MAGNASTOR System

Docket No. 72-1031

RESPONSE TO THE

REQUEST FOR ADDITIONAL INFORMATION

Figure 6-8.1 Canister Interior Moderator Density Study (1800 ppm Boron)

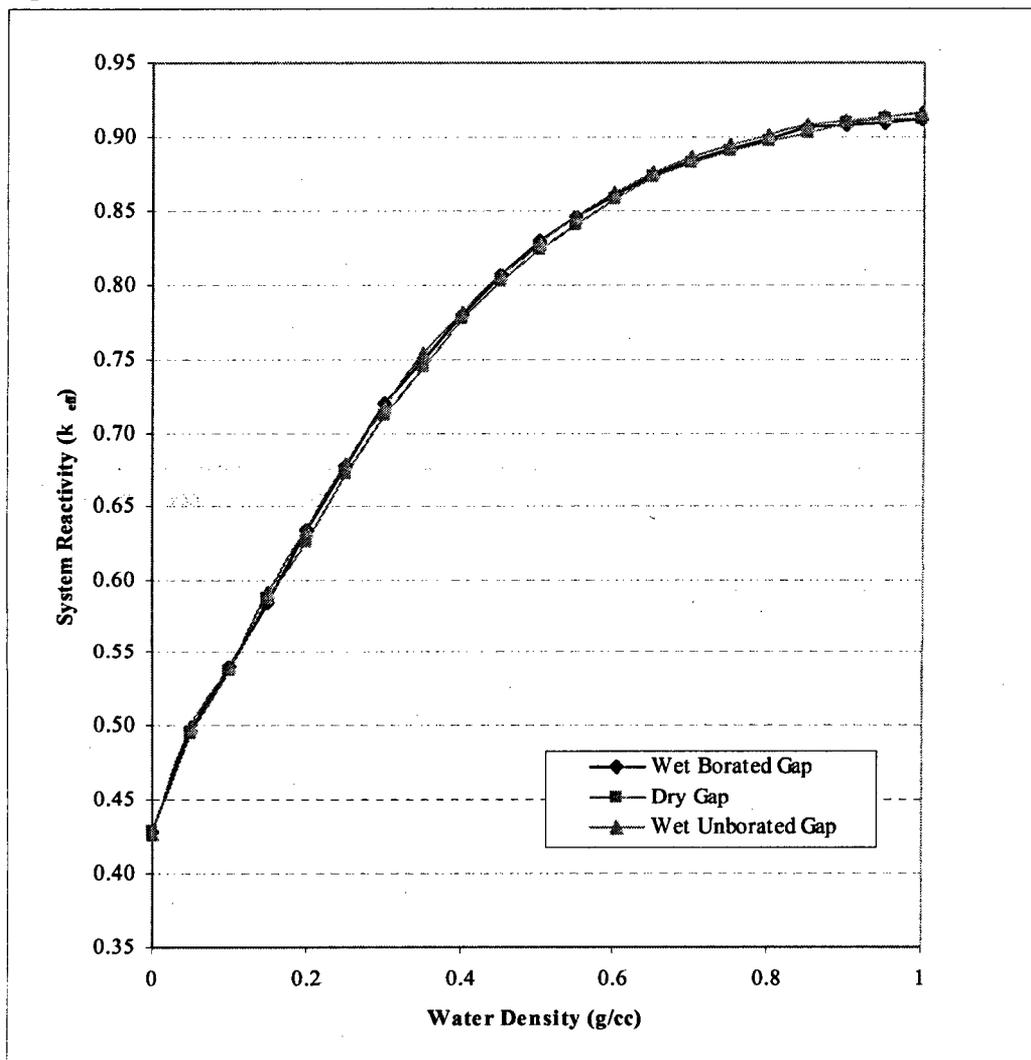
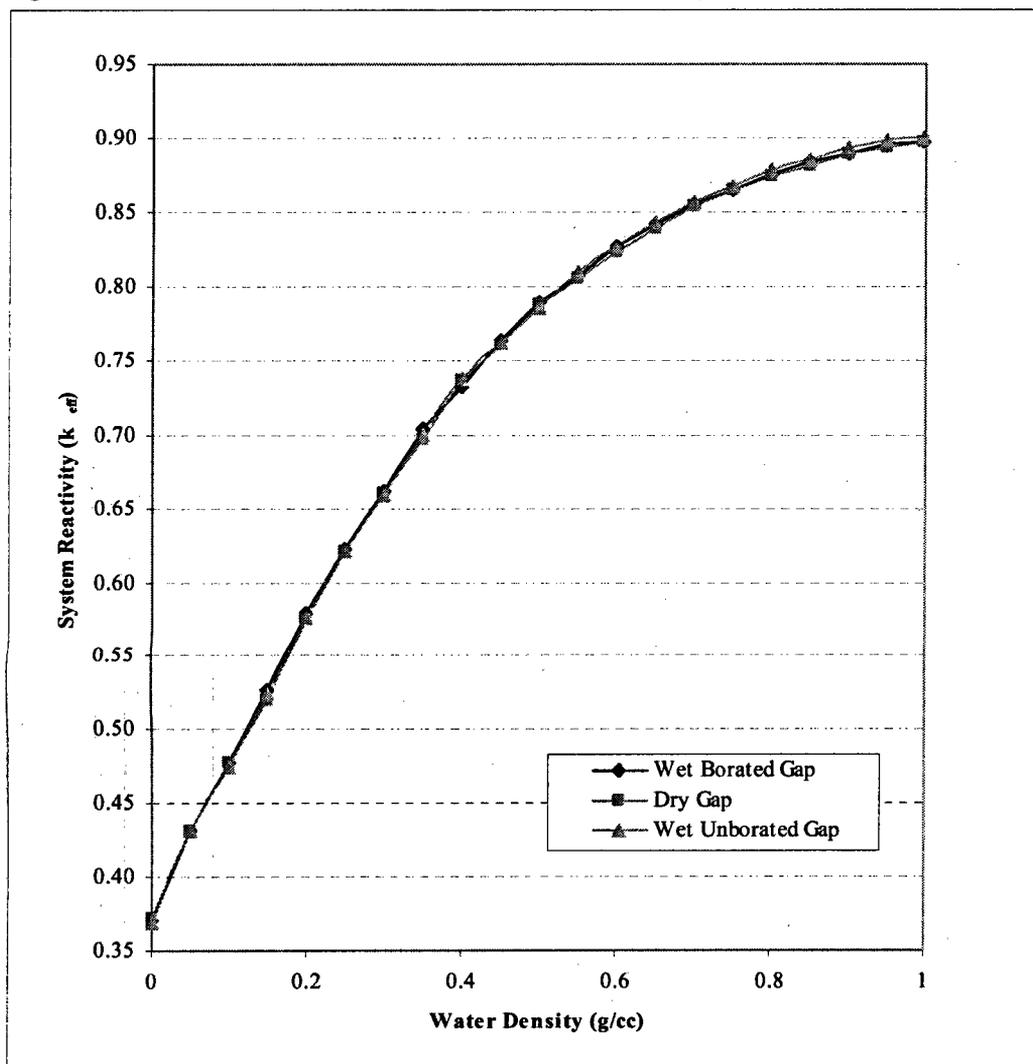
- 6-8 Clarify whether the pellet-to-clad gap in the analysis used to generate the curves in Figure 6.C-1 was modeled as dry, wet with borated water, or wet with fresh water.

The data presented in Table 6.B-1 suggest that some of the assembly types have reached a condition of being over-moderated with high boron concentrations in full density water. The condition assumed in the gap could influence the results plotted in the Figure 6.C-1.

Data presented in Figure 6.C-1 included dry pellet to clad gap data for a soluble boron level of 2500 ppm. The figure is replaced by a data set containing results for an unborated water pellet to clad gap. The gap condition is added to the text description of Figure 6.7.3-1 in Section 6.7.3.1 (formerly Figure 6.C-1 in Section 6.C.1). Also added to the SAR is a figure containing results of moderator density studies for systems with a dry, borated wet, and unborated wet pellet to clad gap (no significant reactivity impacts are associated with canister exterior conditions for a flooded, or near full density water, canister). All three gap conditions provide similar results in that reactivity levels off in the 90-100% water density range (system is at, or near optimum moderation). NAC generated similar moderator density curves at 1800ppm and 1100ppm as shown in RAI response Figures 6-8.1 and 6-8-2. These plots indicate that at lower soluble boron content the MAGNASTOR system becomes increasingly undermoderated. Note that the data shown for the lower soluble boron levels also adjusts initial fuel enrichments to retain reactivities below the USL.

Figure 6-16.2 82-Assembly Basket Moderator Density Variation Study
Dry Pellet to Clad Gap (B9_79A, 4.5 wt% ²³⁵U)

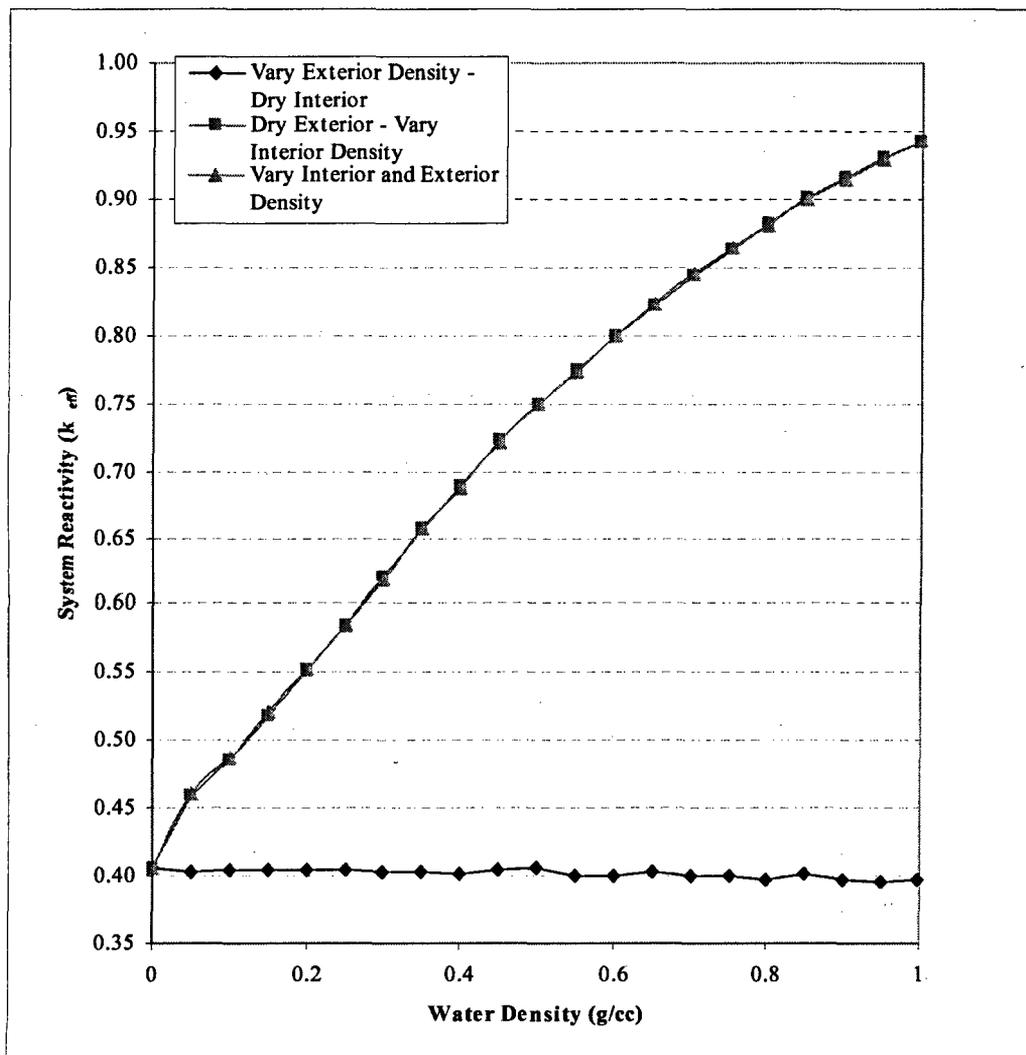
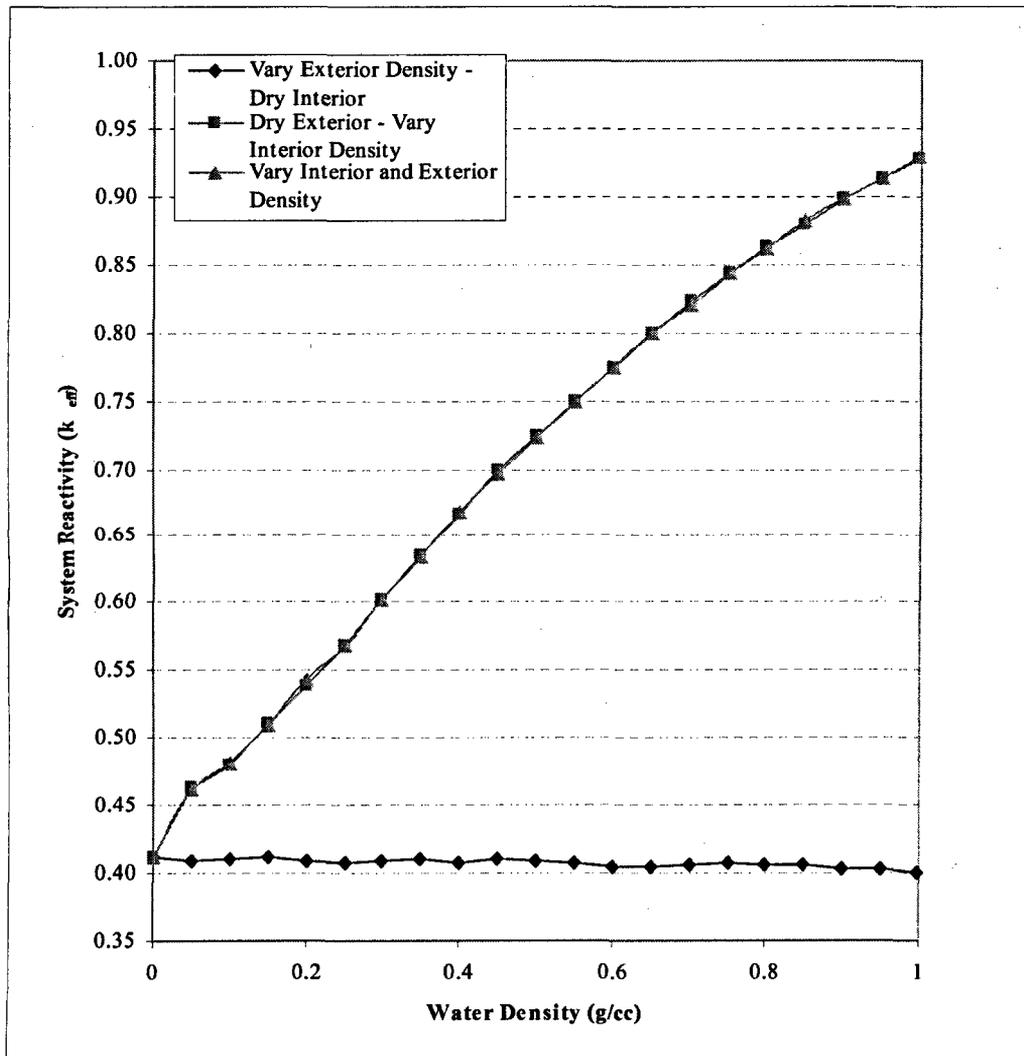
- 6-16 Provide an analysis similar to that in Figure 6.F-1 for the case when only 82 BWR assemblies are allowed in the basket.

Figure 3.10.1-4 Free-Body Diagram of Basket Support Structure

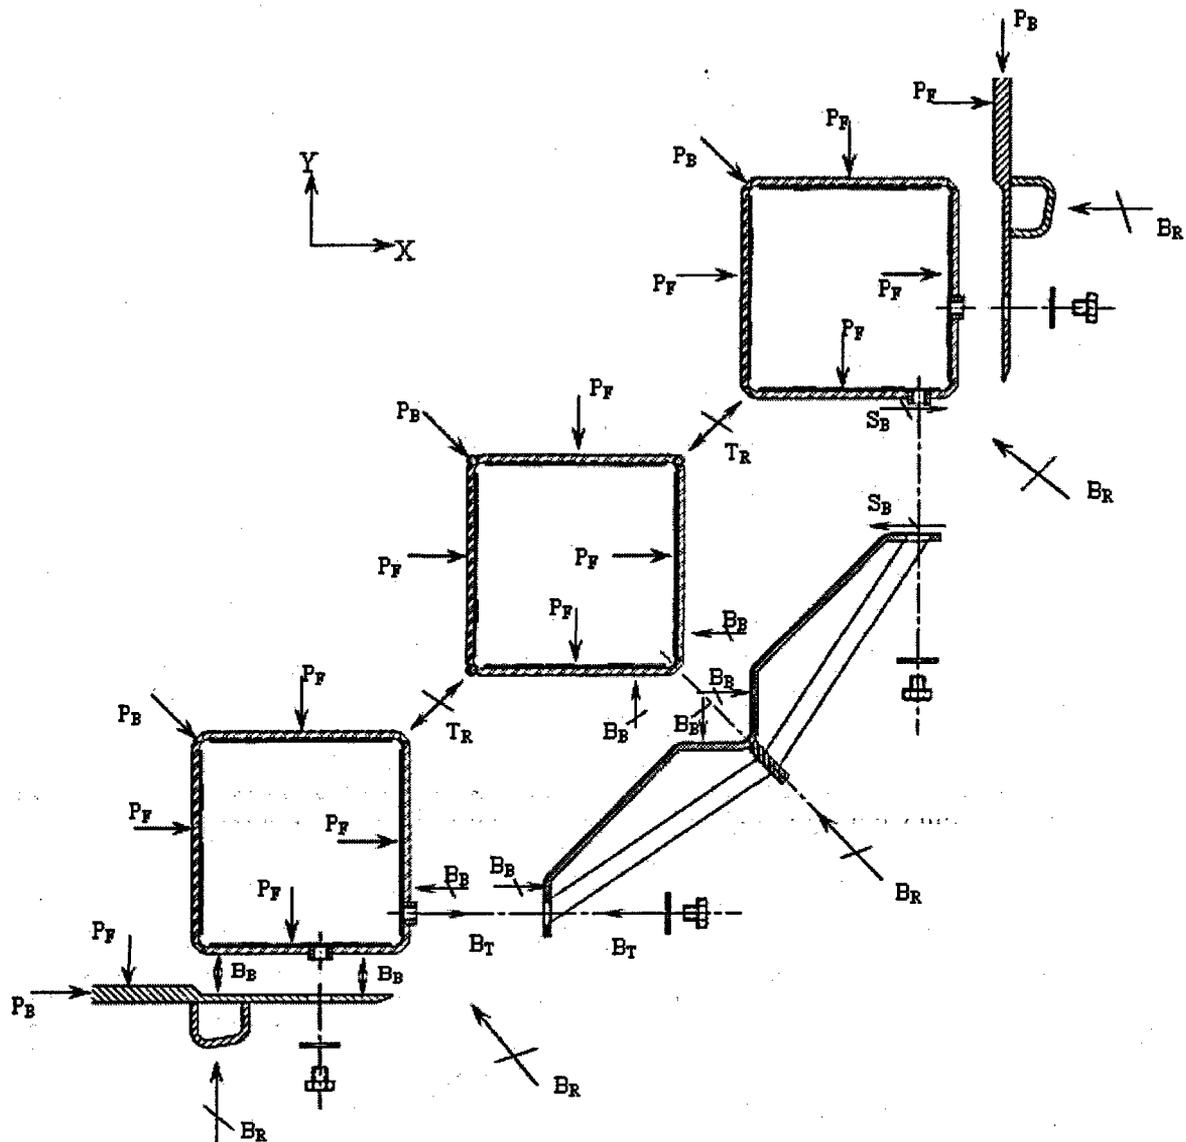
- 3-15 For the middle fuel tube shown in SAR Figure 3.B-4, discuss how its rigid body rotation about the Z-axis can be averted during the cask tip-over accident over the full range of impact and rebound.

Figure 3.B-4 shows that only two out of four corners of the subject tube are constrained from diametrical displacement, which is statically unstable in the X-Y plane. Clarify the design provisions that are accorded to this inherently unstable tube array configuration to alleviate potential fuel basket collapse during the cask tip-over accident.

Sections 3.A and 3.B have been renumbered to be 3.10.1 and 3.10.2, respectively. As shown in Figure 3.10.1-4 (previously Figure 3.B-4), the middle tube is actually constrained at three (3) corners of the tube (the two corners with T_R and the upper left corner with P_B). Therefore, the stability of the middle tube is assured. This middle tube has also been shown to be stable in the finite element analysis of the fuel basket for the tip-over accident event.

Figure 3.10.1-10 Typical PWR Fuel Tube Pin Finite Element Model Details

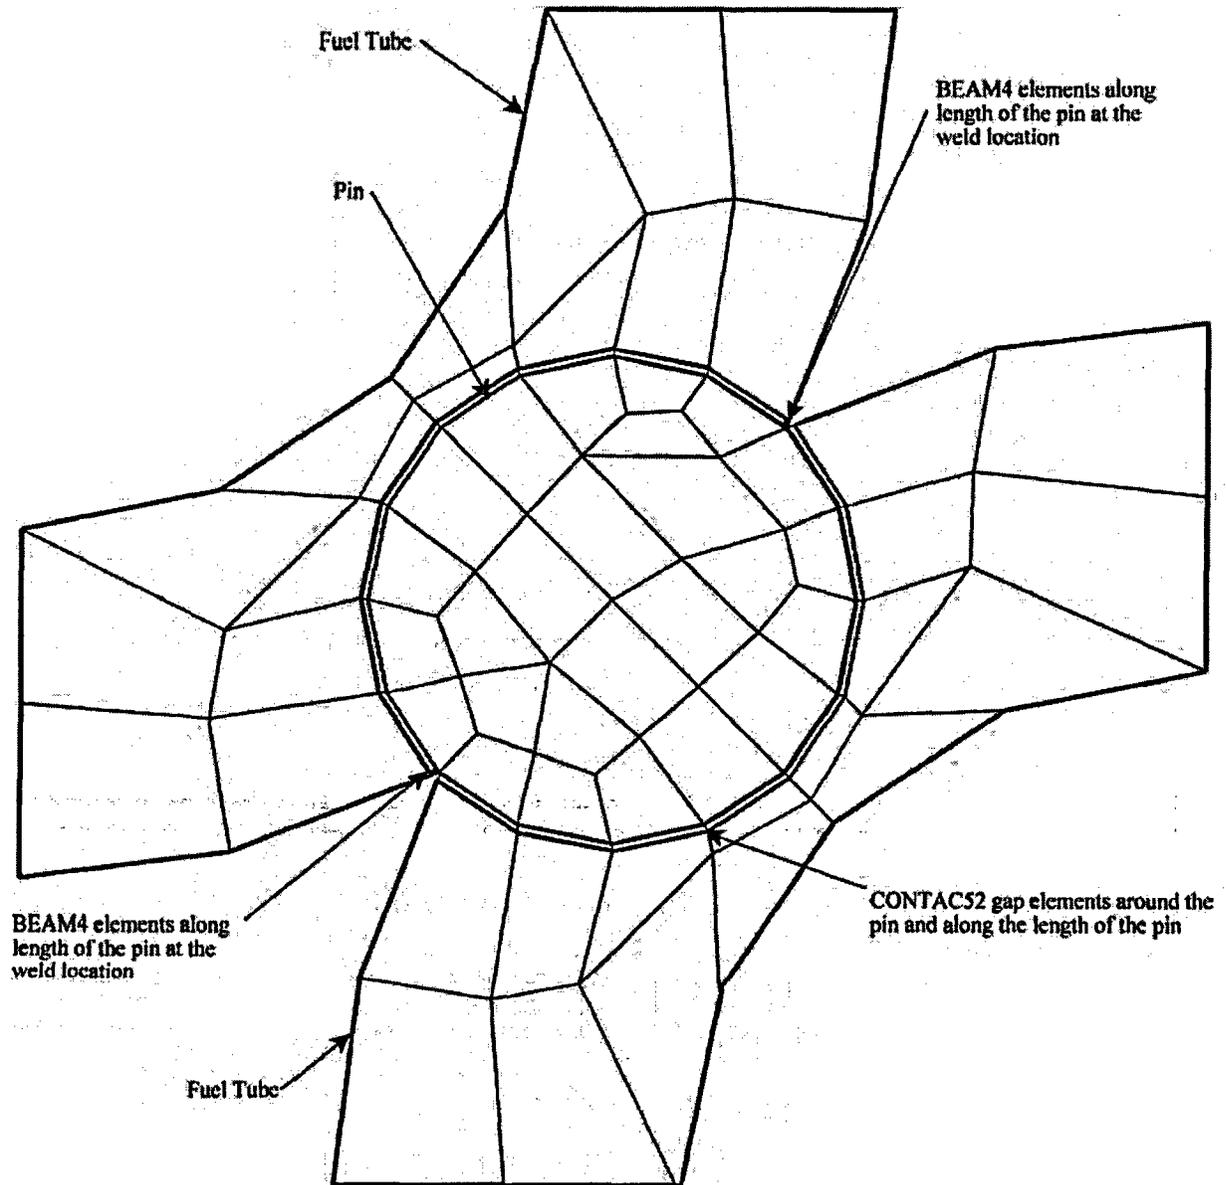
- 3-6 PWR Fuel Tube Evaluation - Revise SAR Figures 3.7-2 and 3.7-4 to provide sufficient description of finite element modeling details for the pin-to-socket connection by also recognizing, as appropriate, physical attributes of the pin and socket recess for force distribution consideration at the connection interface. (Note: This request also applies to the BWR fuel tube evaluation.)

Figures 3.10.1-10 and 3.10.2-10 have been added to the SAR to show the modeling details of the pin-to-socket connections for the PWR and BWR fuel baskets, respectively. The interface between the pin and the fuel tube socket is represented by the ANSYS CONTAC52 gap elements. For the periodic models, BEAM4 elements with minimal properties (Area = 0.001 inch²) are defined at pin-to-socket weld locations. The purpose of the BEAM4 elements is to prevent numerical instability during the ANSYS solution of the finite element models. The BEAM4 elements have an insignificant effect on the structural behavior of the fuel baskets.

Figure 3.10.3-2 Identification of Sections for Evaluating Linearized Stresses in TSC

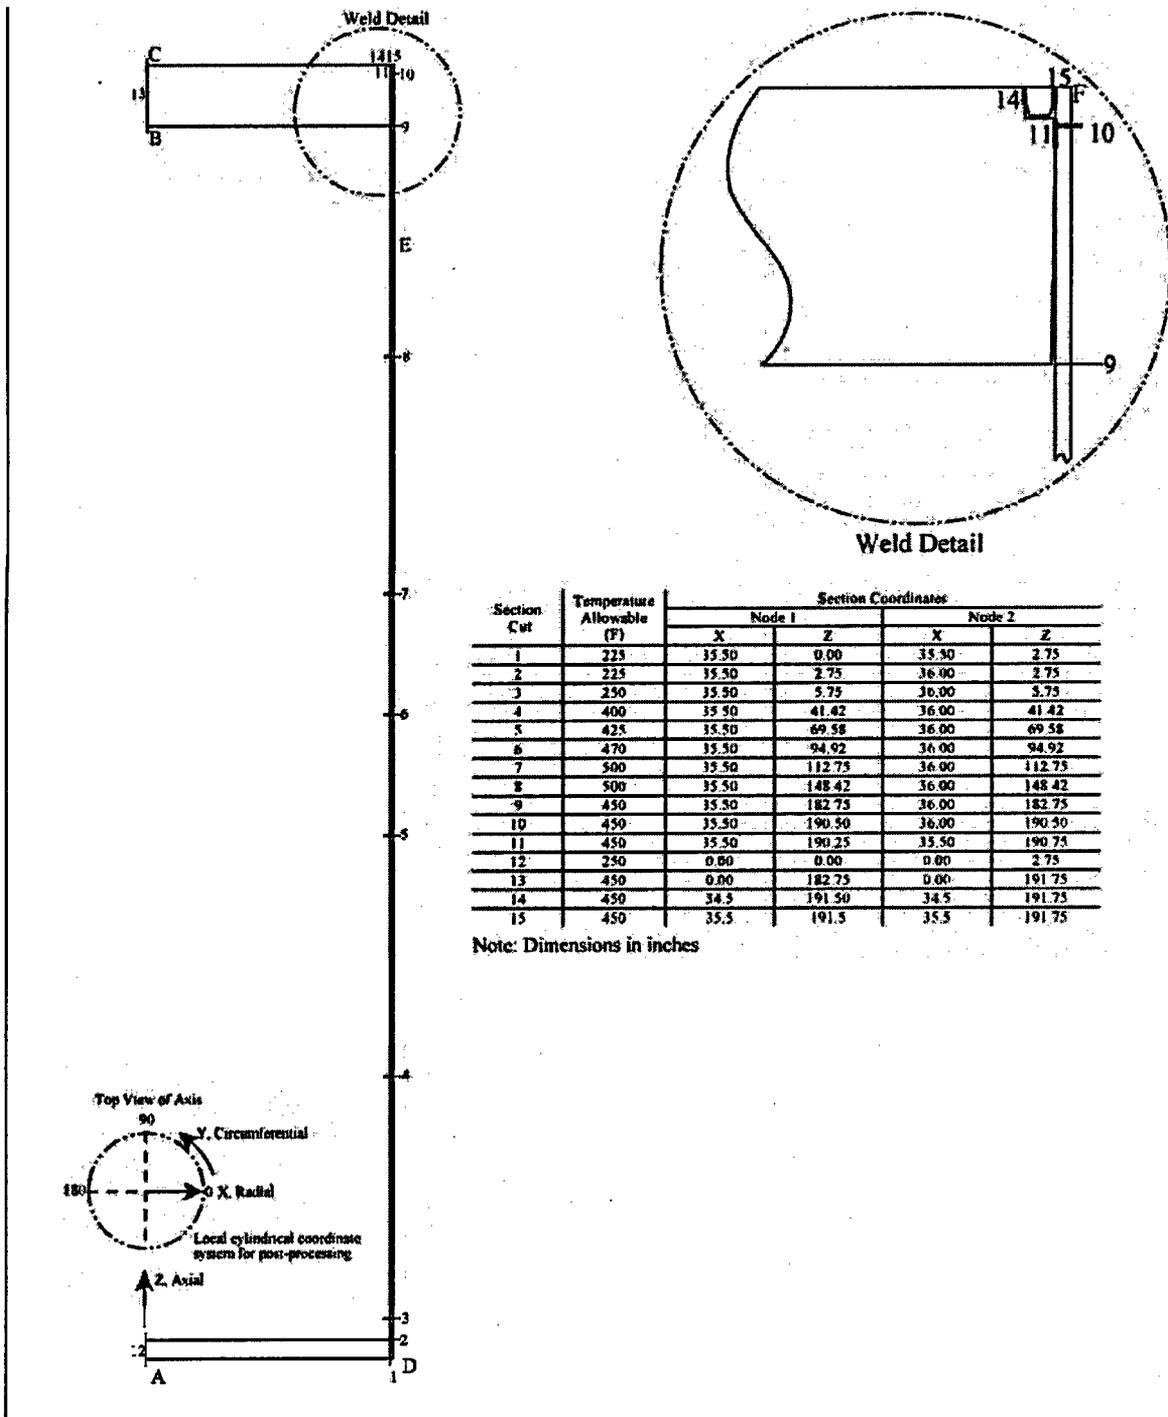
- 3-4 With respect to SAR Tables 3.7.1 and 3.7.2 and Figure 3.C-2, discuss why section cut location 1, in lieu of location 2, was determined to be the most critical for reporting membrane and membrane-plus-bending stresses during the tip-over accident.

Figure 3.C-2 shows that location one cuts right into the 2¾-inches thick TSC bottom plate while location two establishes the interface between the 1/2-inch thick shell body with the bottom plate. By inspection, internal forces developed at section cuts one and two should essentially be in equilibrium. Contrary to those reported in the tables, it appears that the TSC shell is much thinner than the bottom plate, stresses at cut location two should be much more critical than those at location one.
